SERVICE BULLETIN

SUBJECT	DATE
TS-940S AVR UNIT CAPACITOR CHANGE	4-8-86

AVR UNIT (X43-1500-00) Component side view

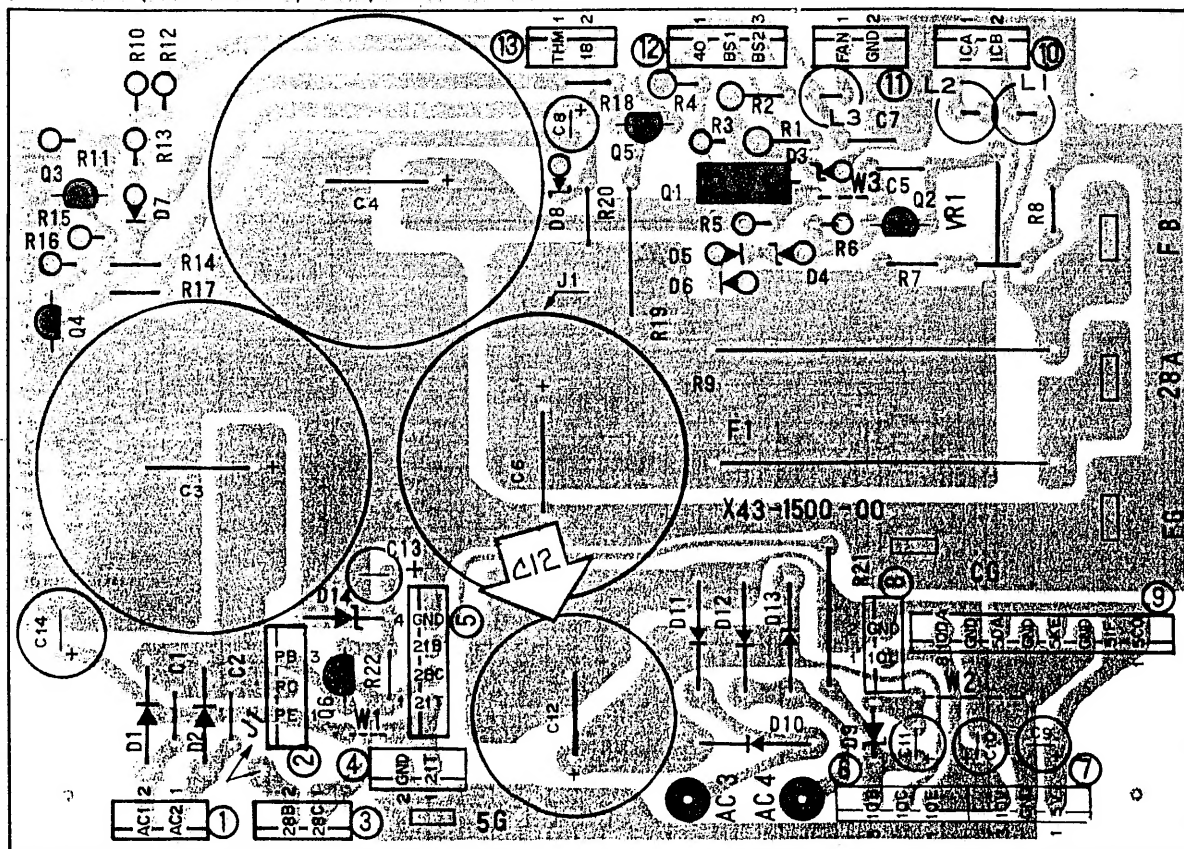
In those areas of the country that are subject to large power line voltage fluctuations, excessive voltage may be applied to capacitor C12 on the AVR Unit (X43-1500-00). These voltage fluctuations might exceed the capacitor breakdown voltage. Replacing capacitor C12 with a capacitor having a higher breakdown voltage will help prevent this potential problem.

On the AVR Unit (X43-1500-00) change C12 from a 6800 μ F capacitor to a 5600 μ F 25 v capacitor (C90-2037-05).
